**Response to request for review of project activity "Yunnan Lincang City Nanlinghe  
1st level Small-scale Hydropower Project" (Ref. no. 2812)**

## **Response to the CDM Executive Board**

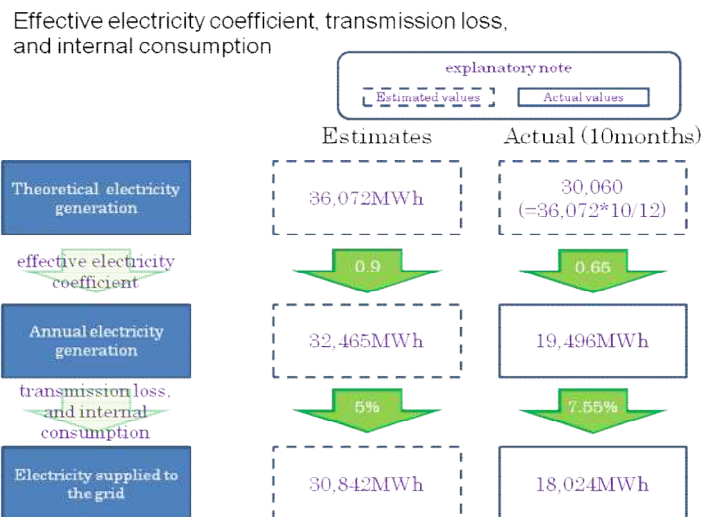
The DOE should further validate the 0.9 effective electricity coefficient and the 5% transmission loss and internal consumption used in the investment analysis, in line with VVM parag. 109 and 112.

Meanwhile, the accuracy and suitability of the parameters were assessed in a cross-check manner. Deloitte-TECO reviewed differences between the estimates and actual values of the annual electricity for the proposed project, which were provided in the PPs' response. The actual data was based on 10 month operation from the start-up (Jan 2009 through Oct 2009). The data was summarized in the following drawing:

Actual values of the above-mentioned electricity supplied to the grid were evidenced by electricity sales invoice, and Deloitte-TECO checked them with satisfactory results. This drawing showed that the effective electricity coefficient calculated from the actual values were 0.65 and more conservative than 0.9 of that calculated from estimated values at the time of FSR. In a similar discussion, the total 7.55% of transmission loss and internal

consumption calculated from the actual electricity supplied to the grid was more conservative than total 5% of those in the FSR. In conclusion, these aspects were considered appropriate in terms of conservativeness.
